CAPITOL ZONING DISTRICT COMMISSION
STAFF REPORT
1/25/2018
JBC / BIM

Location: 705 & 707 Dennison Street
Applicant: Jamie and Ruth Vasquez
Permit Types: Certificate of Appropriateness & Conditional Use Permits

Project Description: This application is for a Certificate of Appropriateness at 705 Dennison to allow for the rehabilitation of a circa 1979, one-story outbuilding as a two-bedroom dwelling unit. The 1,120-square-foot structure constructed of concrete blocks would see extensive remodeling under this proposal. The structure currently contains no windows, doors, or a roof. The application calls for reusing some of the existing window openings, while enclosing some others and creating some new ones. Windows will be single-hung vinyl models, with one glass-block window on the south side of the structure. The missing roof will be replaced with a gable roof of composition shingles. Stucco will cover the concrete-block walls. A six-foot masonry fence of concrete blocks will be placed behind the outbuilding along the rear property line. A matching stucco will cover the blocks.

East and West Elevations

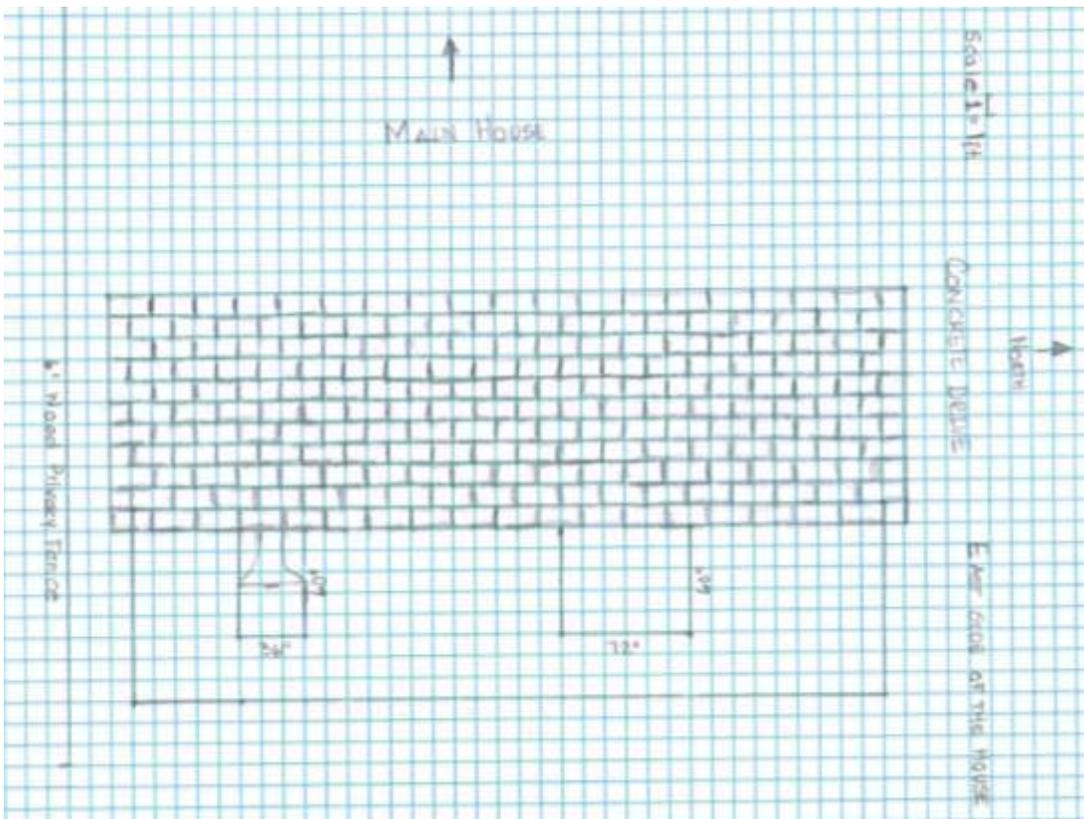
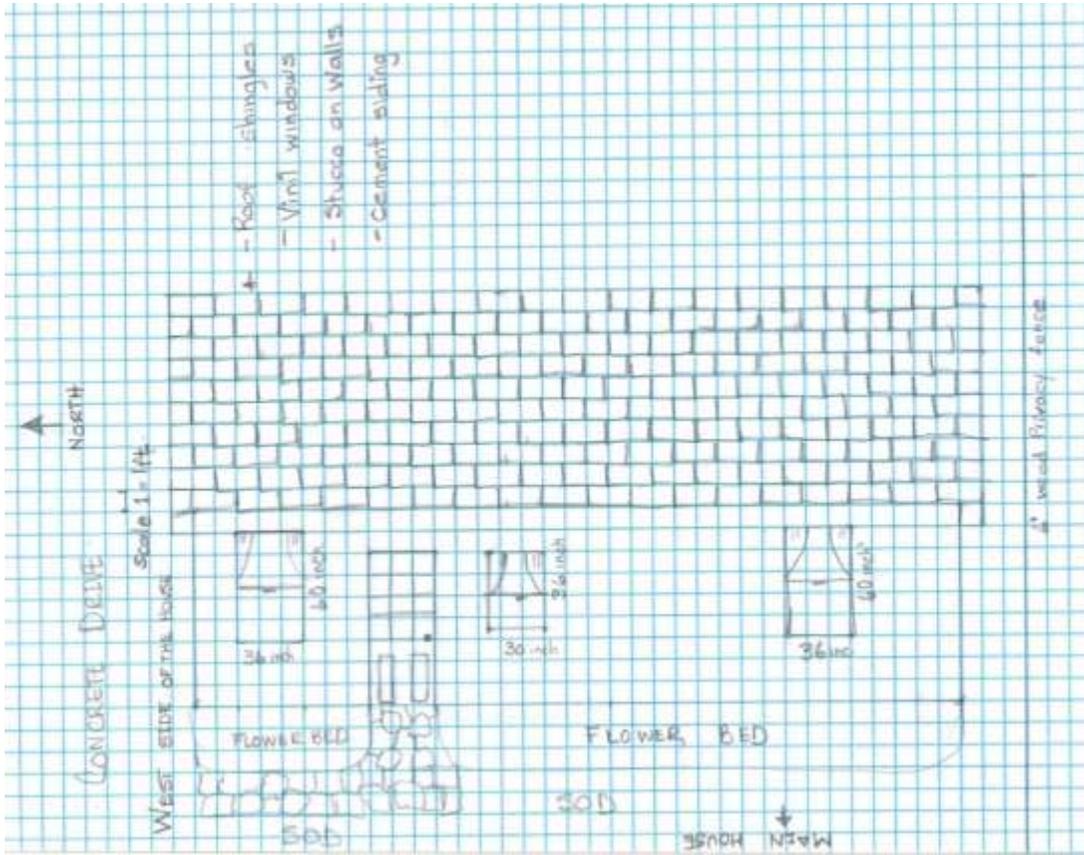
Staff finds that the proposal to cover the building with stucco is NOT consistent with these standards. Though many consider stucco an attractive building material, the current concrete block construction is actually more in keeping with the traditions of the State Capitol Area. On the other hand, the proposed guest house is an ancillary building, only partially visible from the street, whereas these Standards were written for principle structures.

- 3) That the outbuilding's roof should have a pitch similar to the main house.

Committee members also agreed that stucco is an acceptable finish for the outbuilding.
